Corrective Action Investigation Plan
for Corrective Action Unit 405:
Area 3 Septic Systems,
Tonopah Test Range, Nevada

RECORD OF TECHNICAL CHANGE

Technical Change No. 1

The following changes were made to reflect the modification to the conceptual model for SWS 4 (CAS: 03-05-002-SW04) based on field investigation observations:

Figure 2-3
Septic Waste System 4:
Northwest Section of Area 3, Tonopah Test Range, Nevada

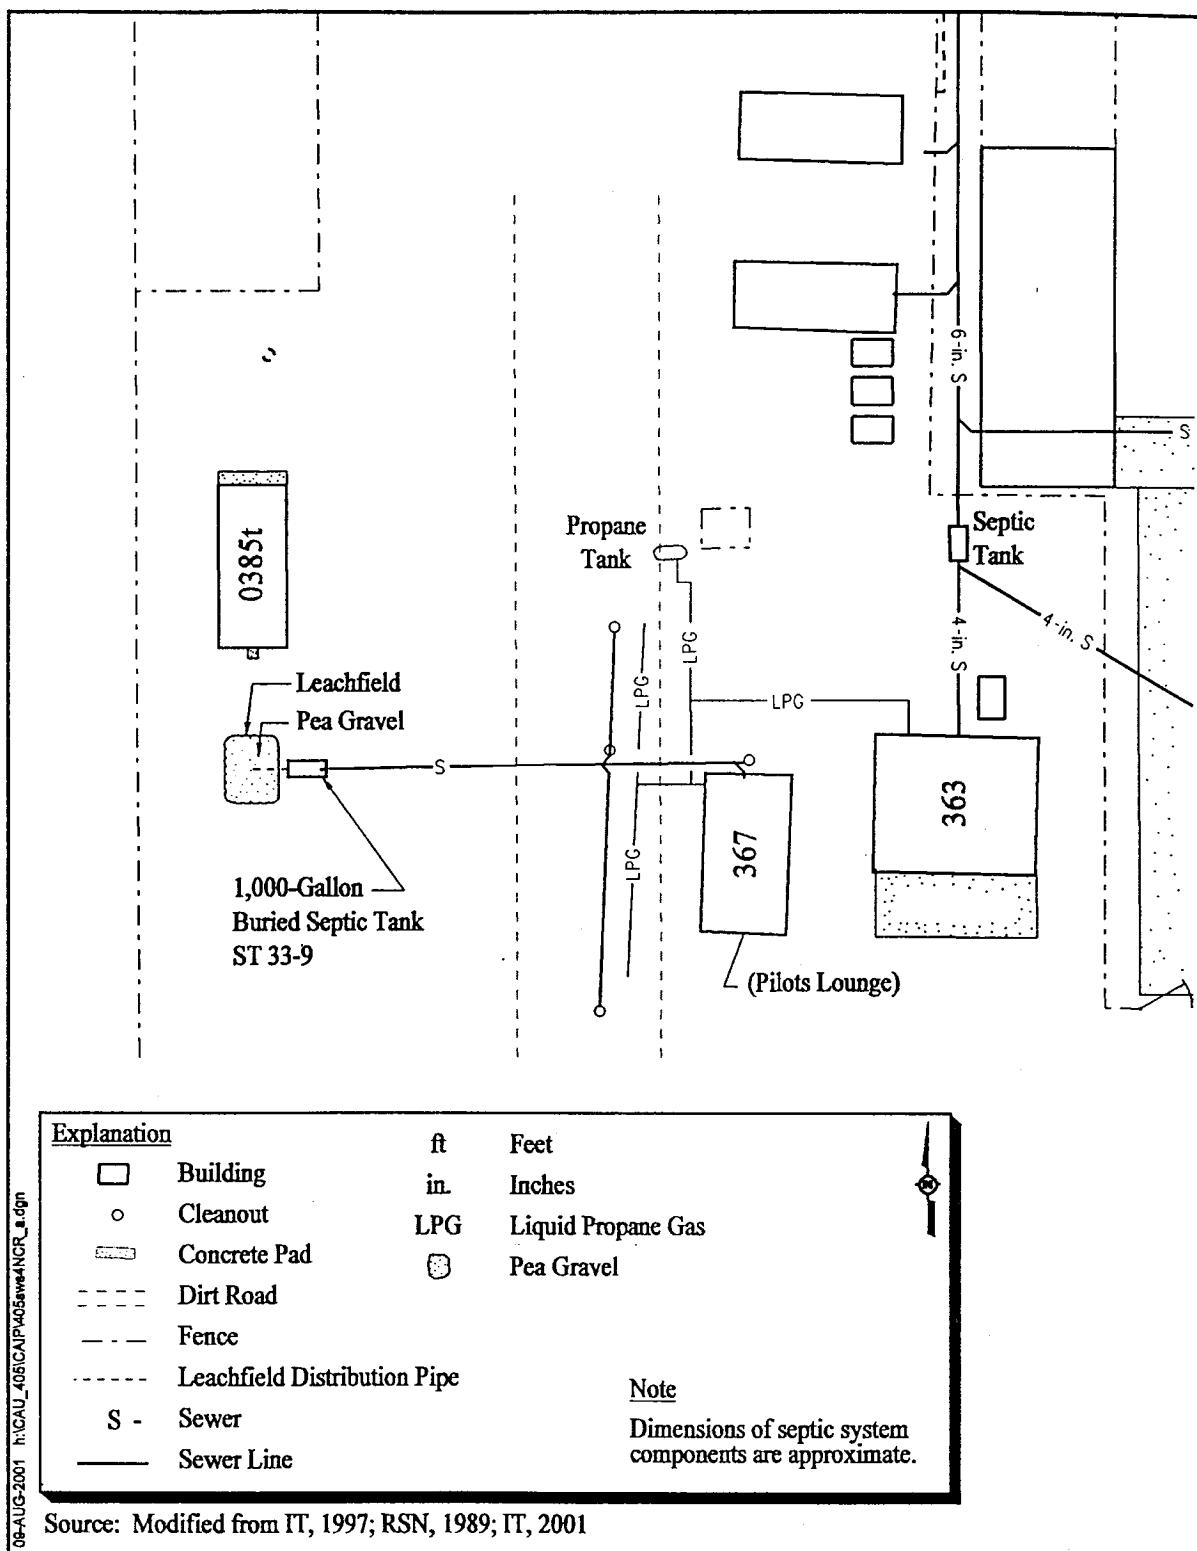
Pages 11, 12, and 27, Figures 2-3, 2-4, and 4-2, respectively

Replace Figures 2-3, 2-4 and 4-2 with the attached revised figures.
